Ref: FCC Class II Permissive change for FCC ID: 2ADH6-190209LC

This is to request a Class II Permissive change for FCC ID: 2ADH6-190209LC originally granted on July 28, 2023.

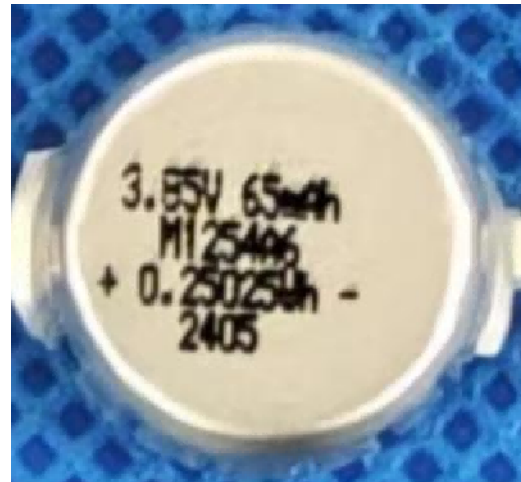
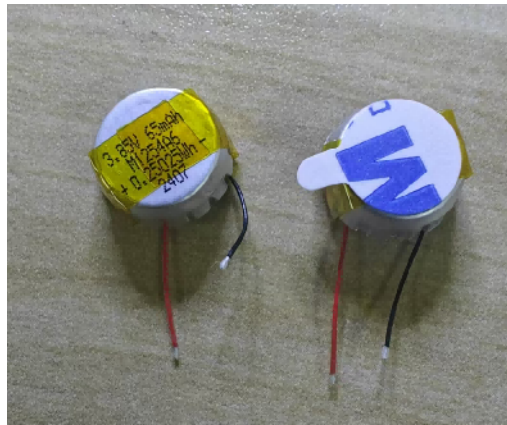
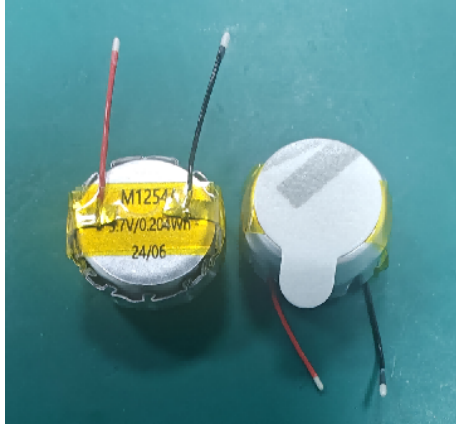
The headphone battery is changed from DC 3.7V to DC 3.85V 65mAh, and the charging bin circuit is changed: the Type-C seat is changed from 6PIN to 16PIN
